ANN ARBOR PLANNING DEPARTMENT STAFF REPORT

For Planning Commission Meeting of September 19, 2017

**SUBJECT: Weber Site Plan (2857 Packard Road)
File No. SP17-004**

SUBJECT: **Site Plan:** 2857 Packard
Location: 2857 Packard
Plans Dated: July 14, 2017
Project Number: SP 17-004

SITE ALTERNATIVE #3

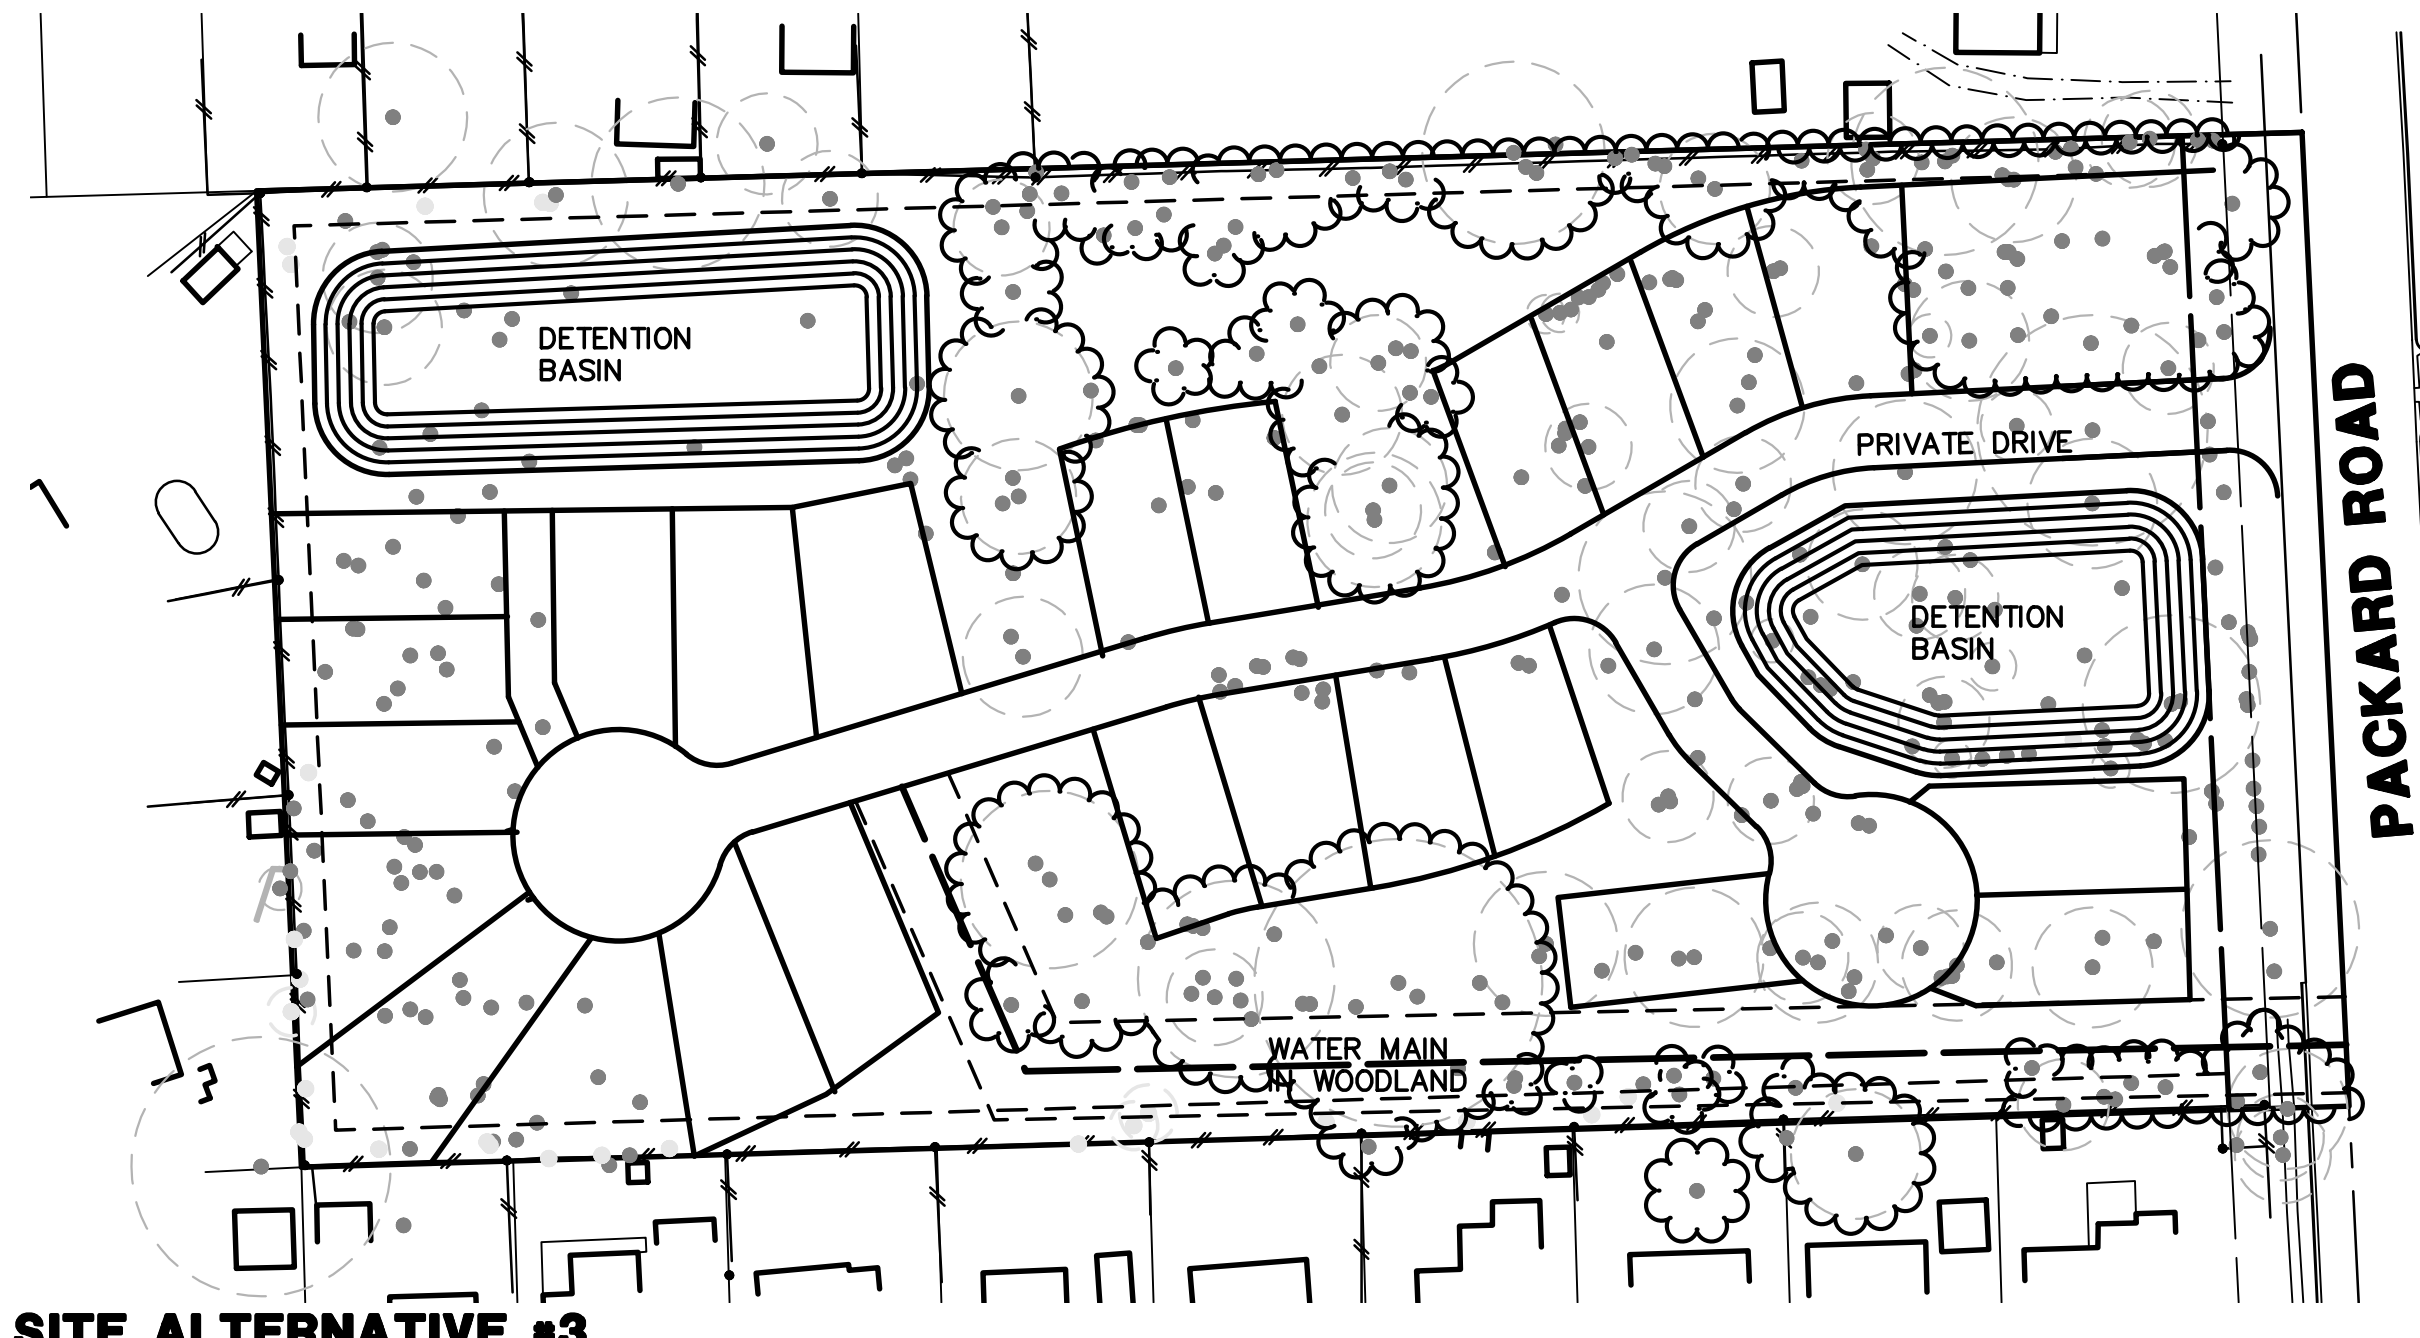
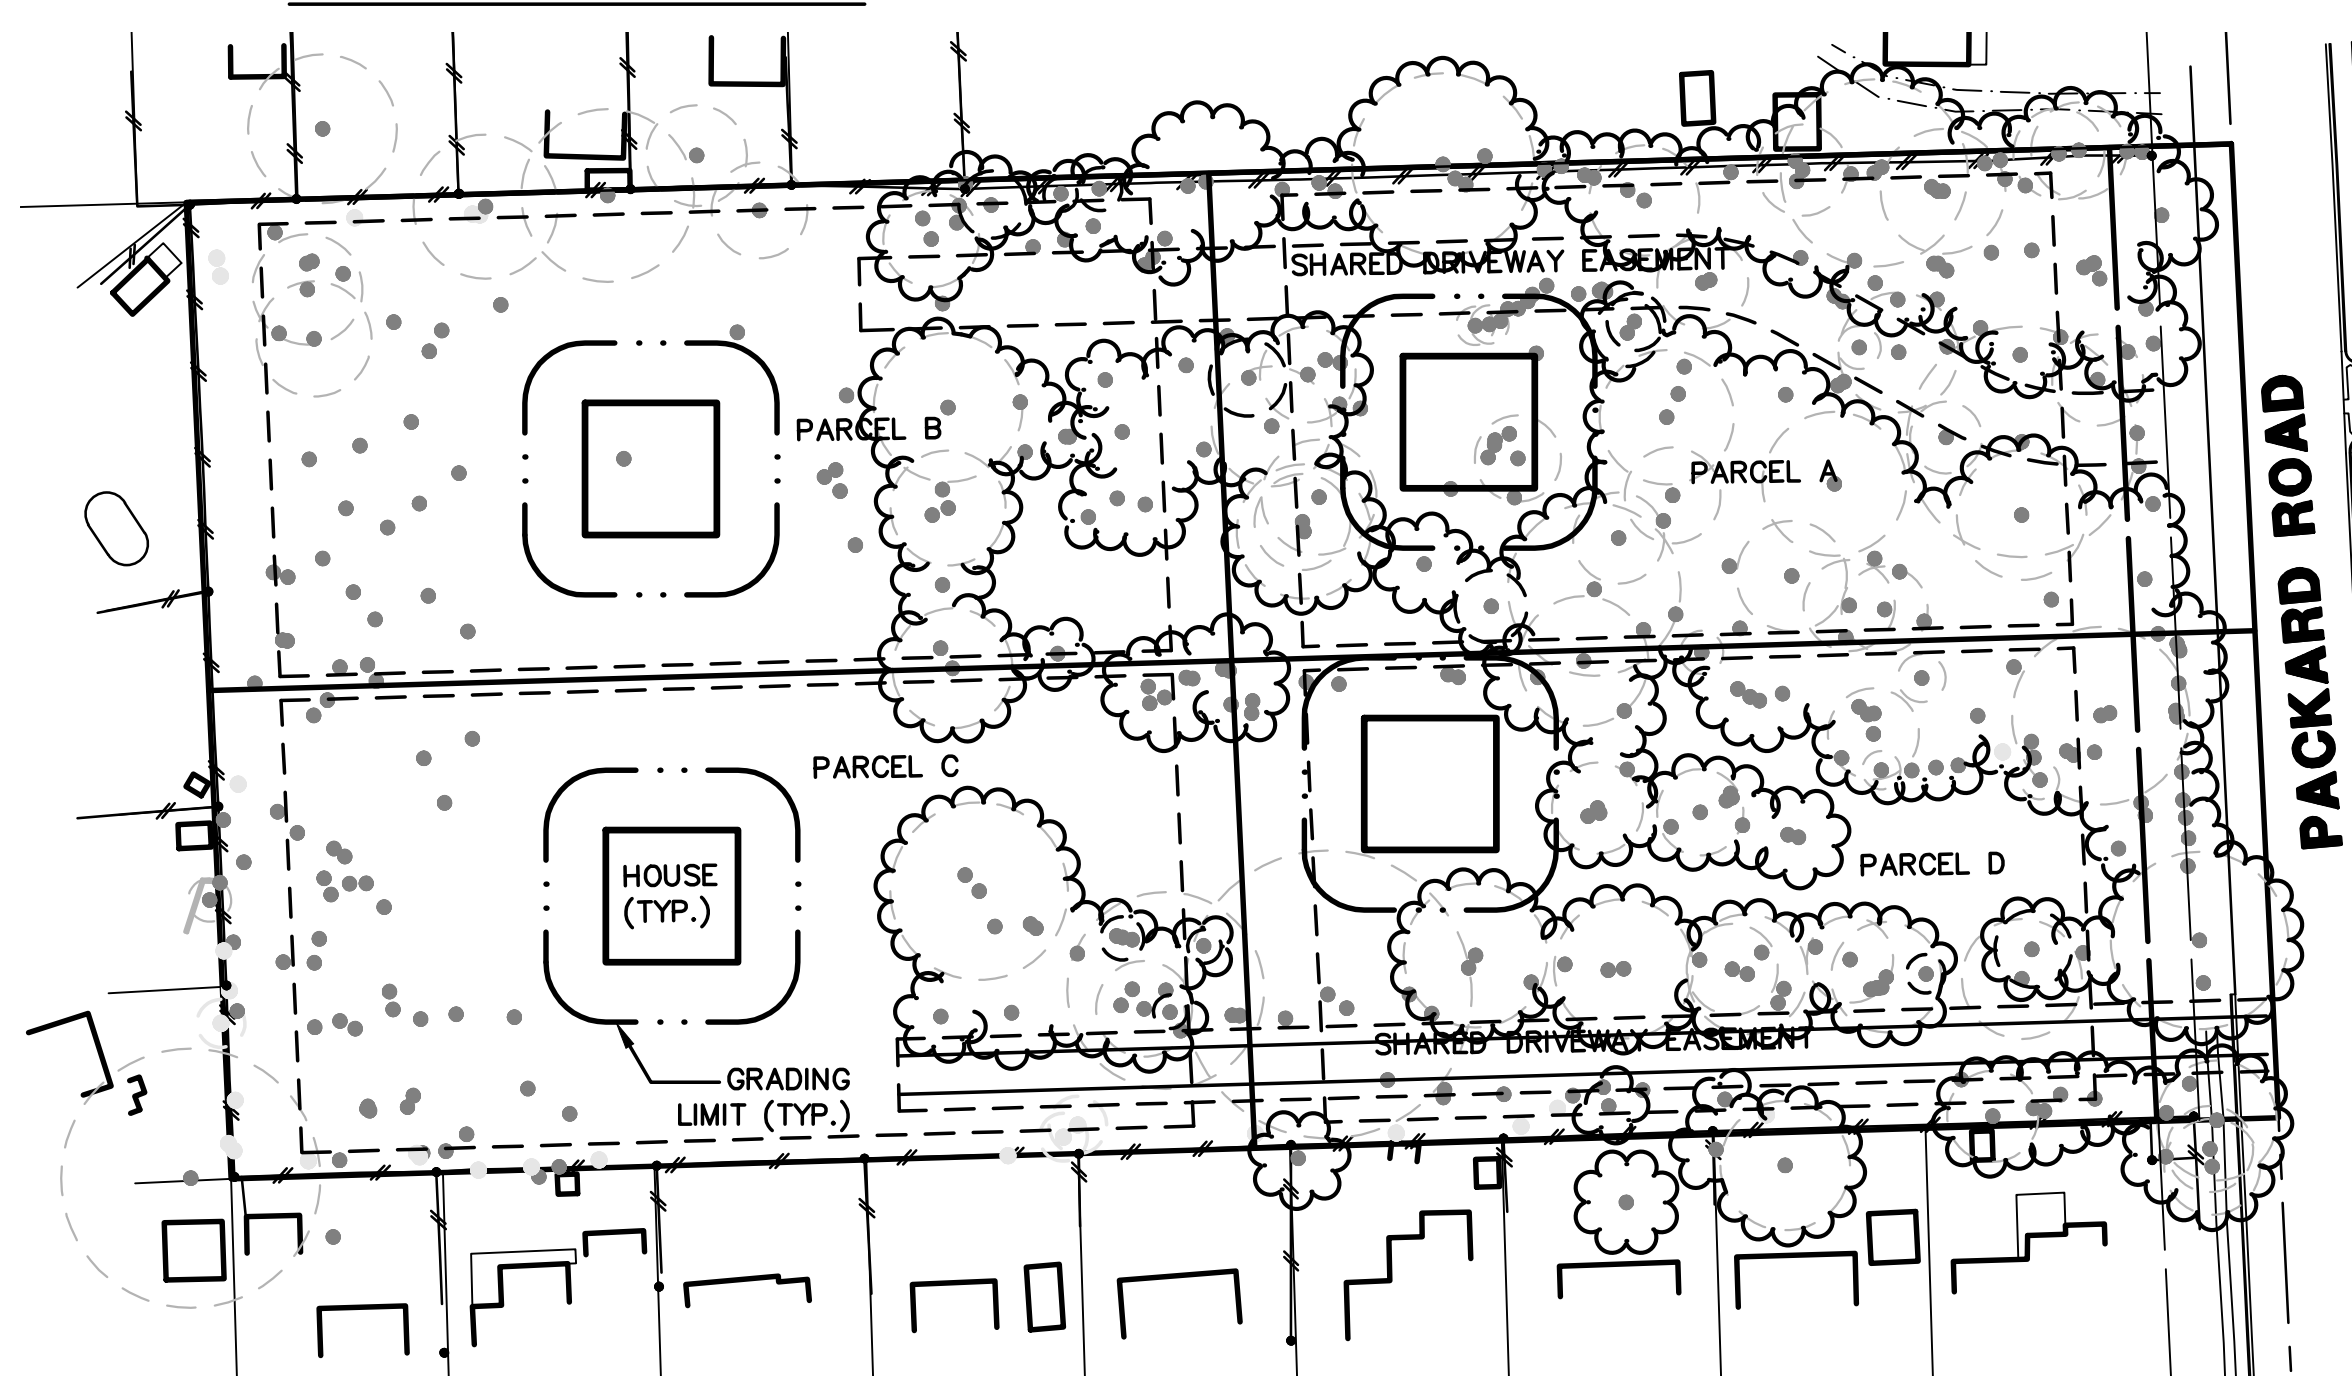
The petitioner provided alternative analysis showing fewer lots with more natural features preservation. Site Alternative #1 contains 40 lots and preserving additional natural features. While there are many constraints on site, any proposed development should be concentrated on the northern three-quarters portion of this site. This demonstrates an alternative plan that provides for a reasonable use of the property, with less impact to natural features.

3. The committee discussed that several of the proposed alternative layouts, presented in the plan set, would preserve more natural features and would allow for a more efficient and effective stormwater management system. These alternative layouts are preferable to the extent that they minimize the natural features impact and lessen the stormwater impacts of this development.
